**CITY OF SANDUSKY
BOARD OF ZONING APPEALS MEETING**

BOARD OF ZONING APPEALS REPORT

APPLICATION FOR A VARIANCE TO ALLOW
A PUBLIC STRUCTURE WITHIN A SPECIAL
FLOOD HAZARD AREA ON THE JACKSON
STREET PIER

Reference Number: BZA-01-19

Figure 4. Partial wet floodproofing technique using flood damage-resistant materials for finished wall construction.

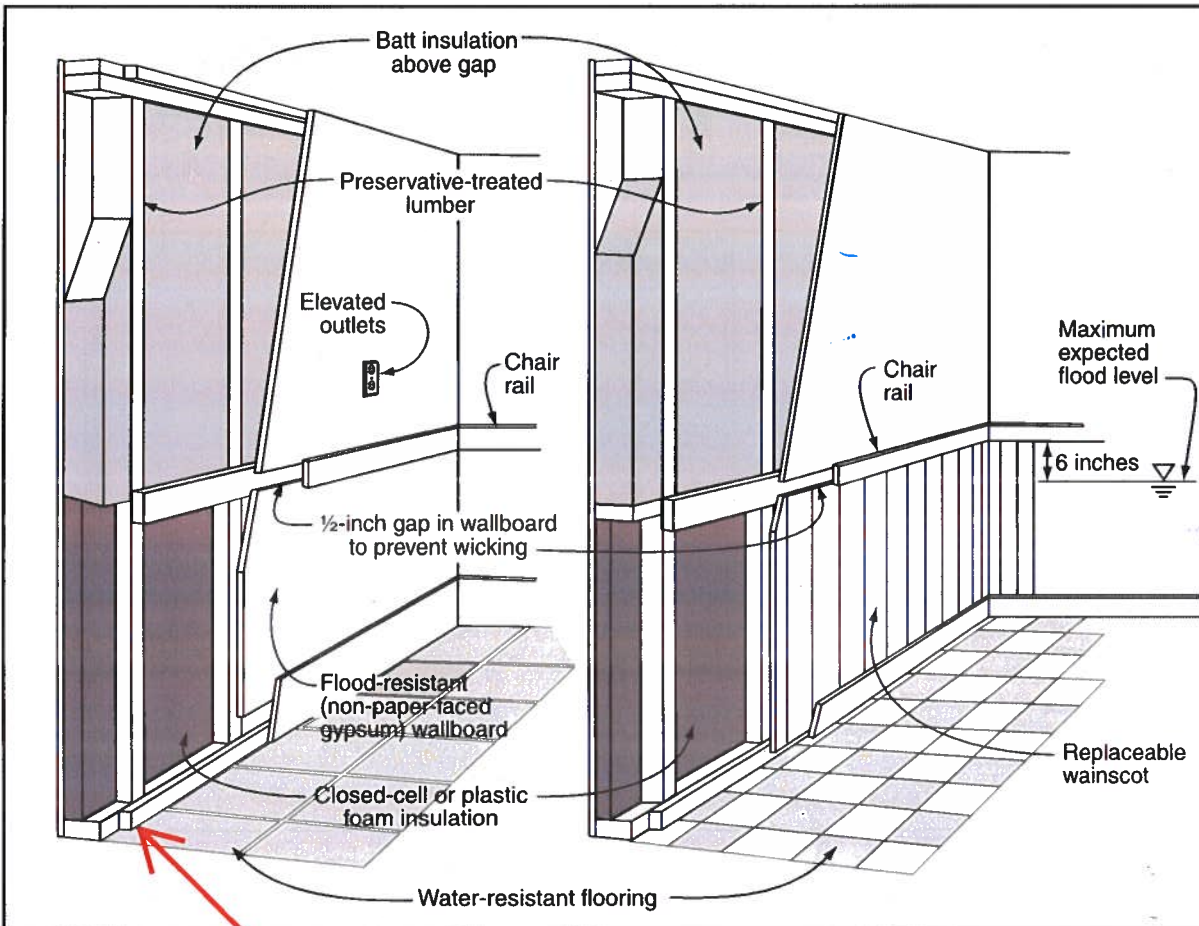
Left wall will be adopted for interior partitions

JACKSON STREET PIER REDEVELOPMENT
MARKET PAVILION BUILDING

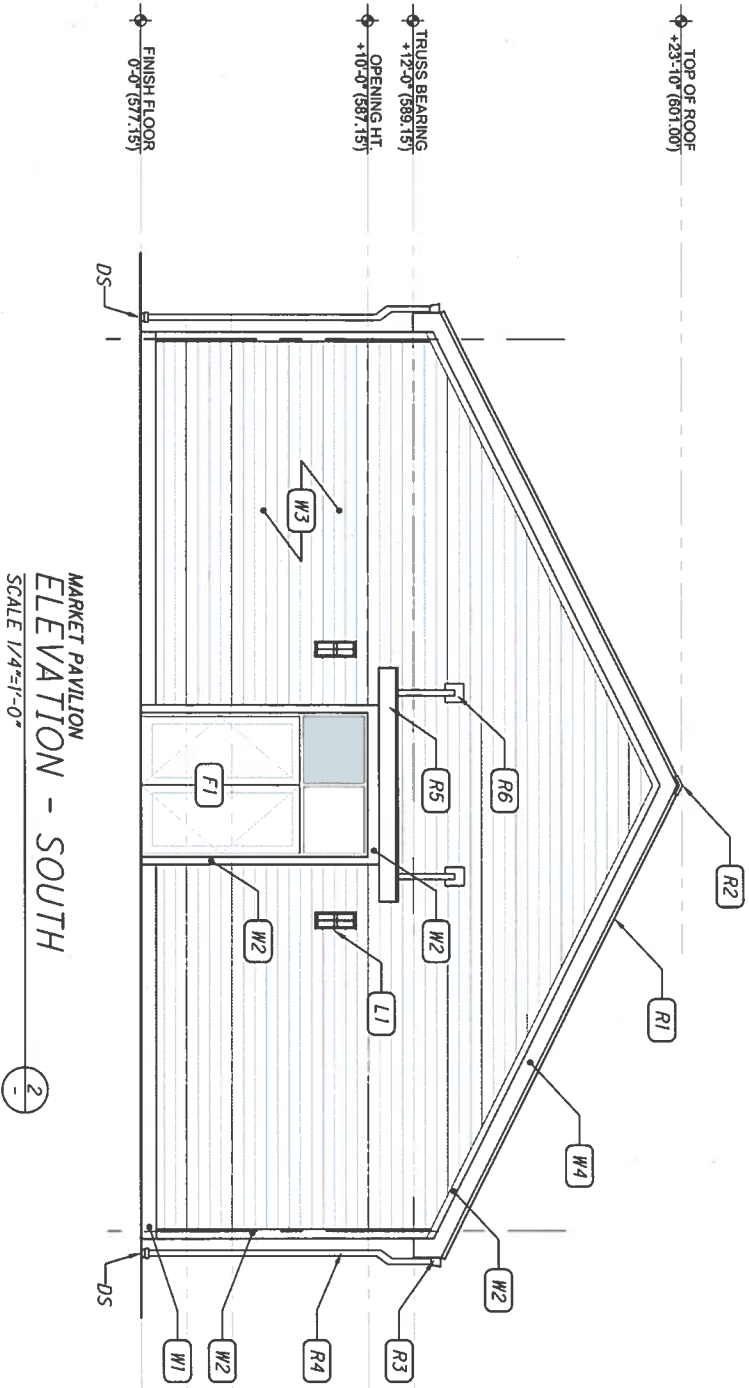
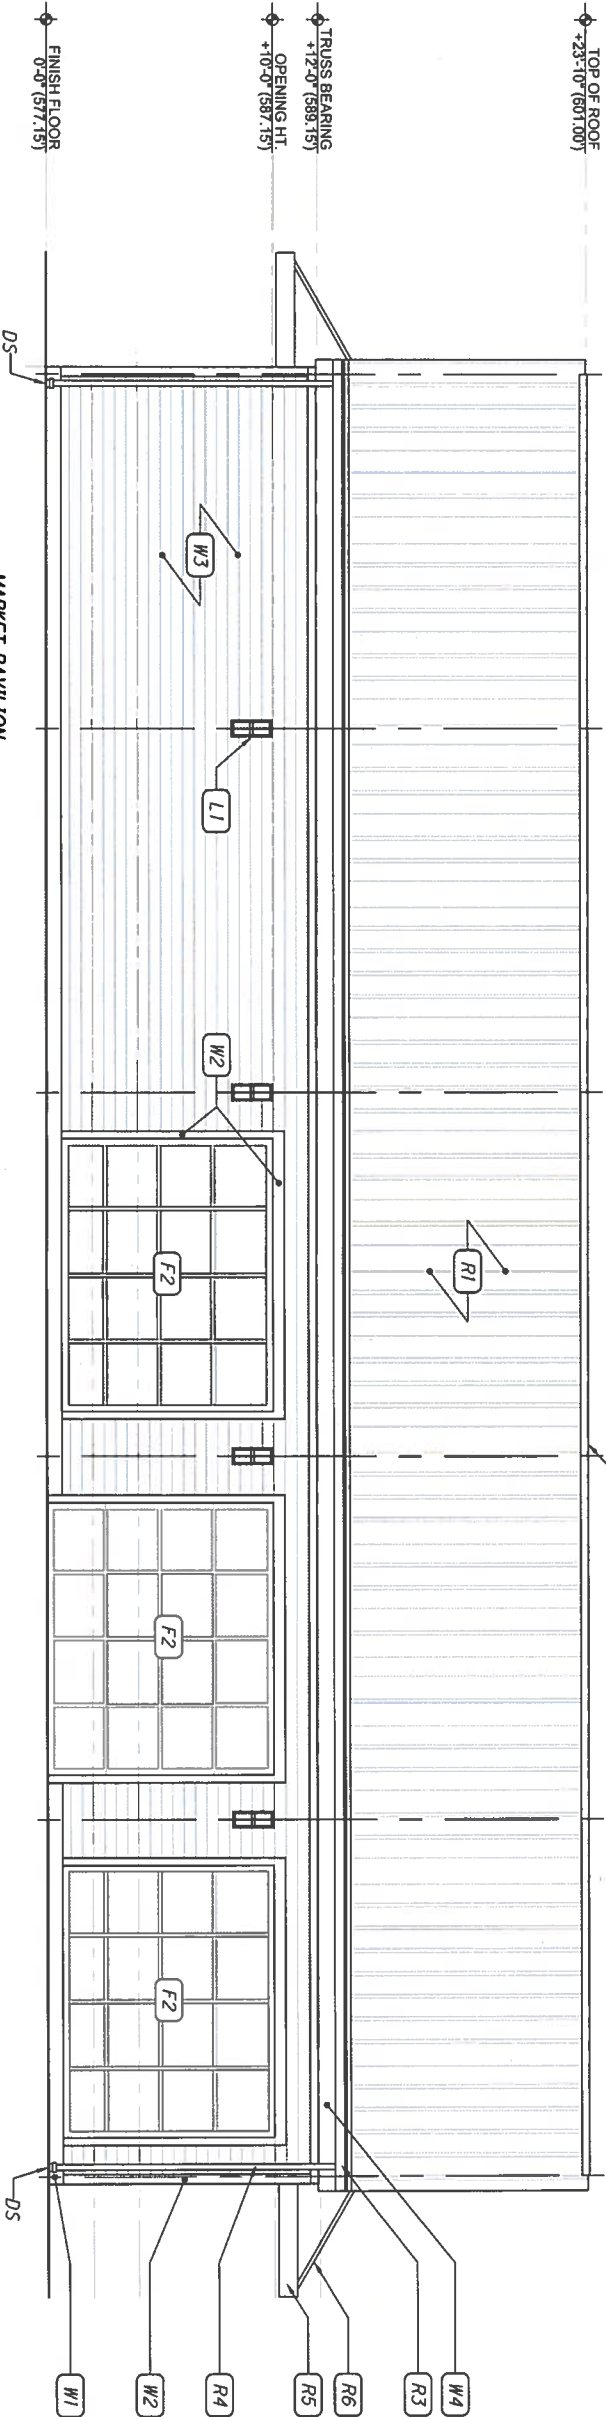
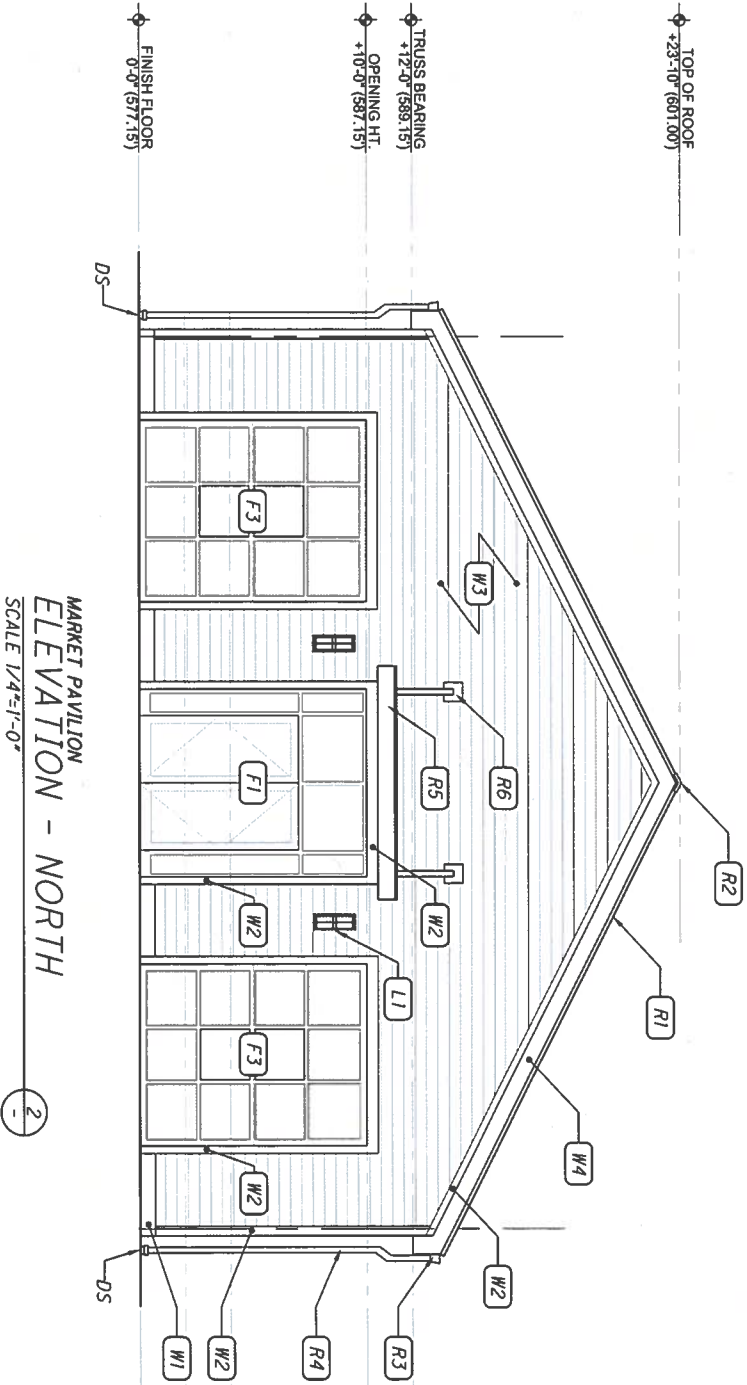
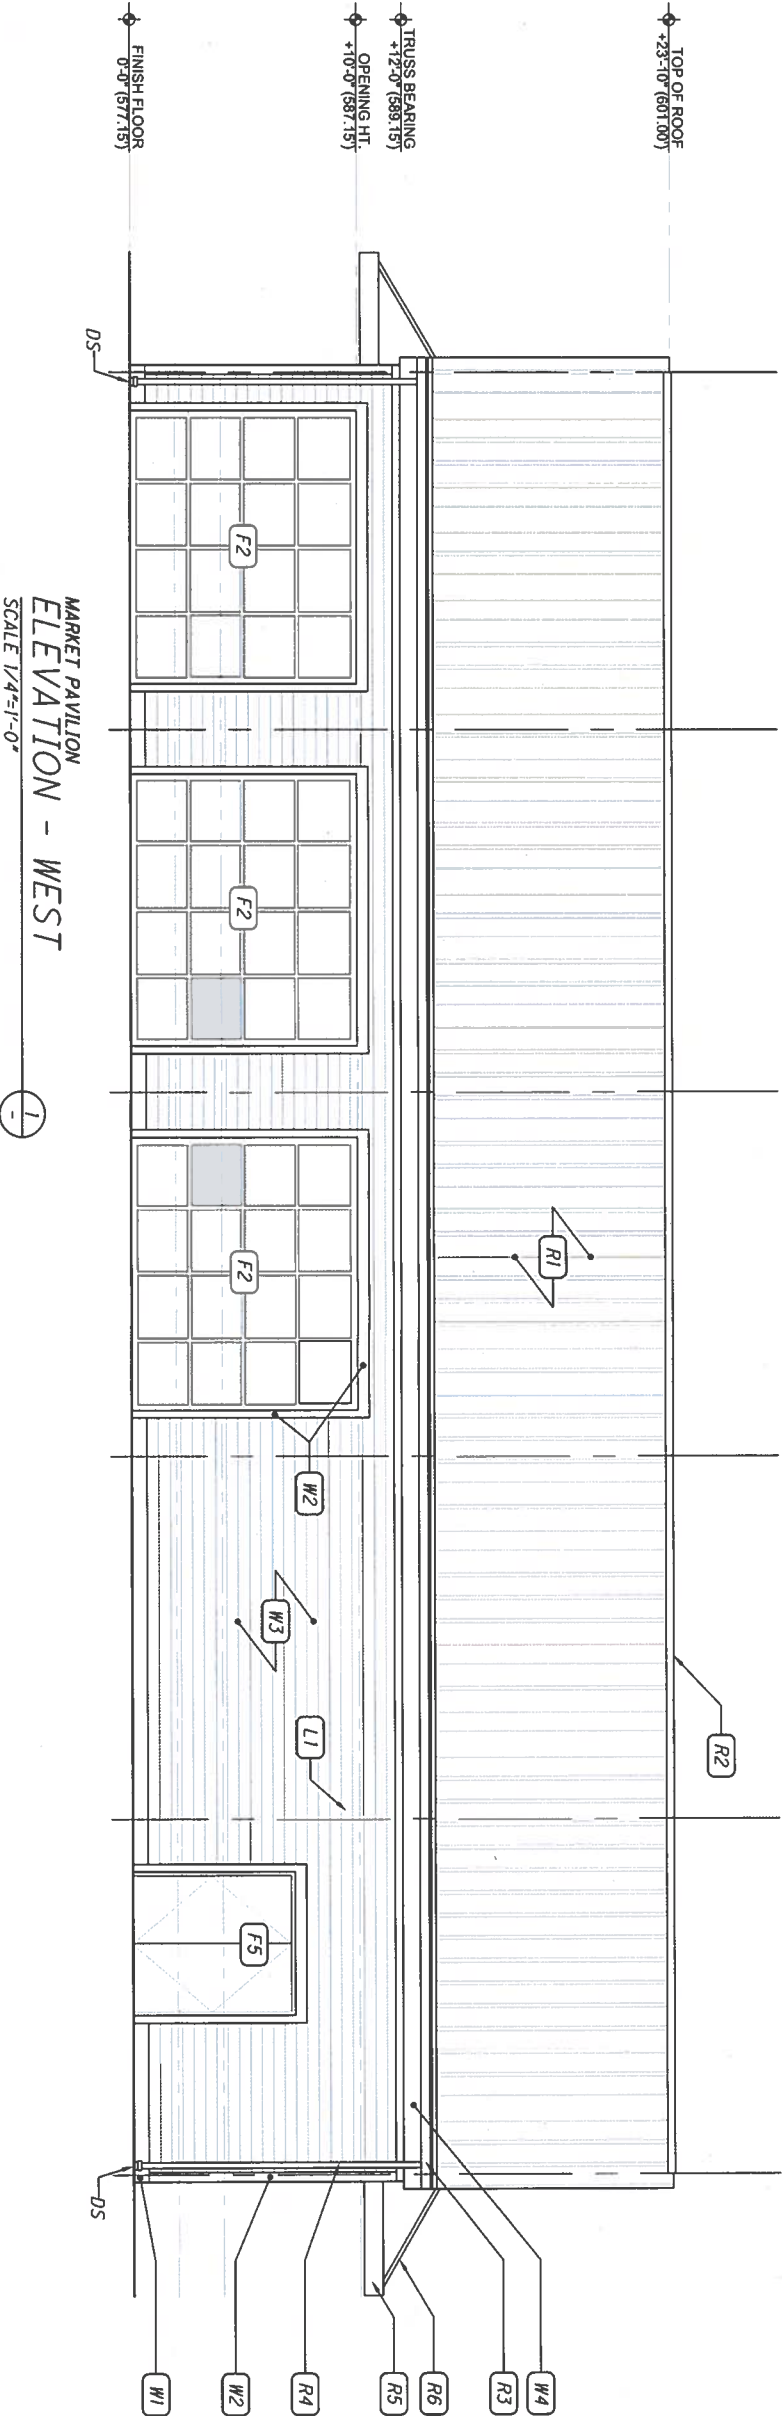
Staff has reviewed and supports the variance request for the **Pavilion**, based on the structure not being used for habitation, the Pier not being open during flooding events and no impact to the Base Flood Elevation is anticipated based on this additional structure.

Staff believes that the proposed location of the pavilion is important because it provides for increased view sheds of the water as well giving it the ability to be more effectively programmed with events. The current site plan was approved by the Planning Commission via a public process. The applicant also stated that the lower portion of the walls of the structure will be constructed with FEMA-recommended materials.

Engineering staff recommends **approval of the Pavilion variance of 1.85' of the 2' Flood Protection Elevation.** Staff and Donley's have been coordinating on the Pavilion, and if required, we will review any changes that could impact this variance request.
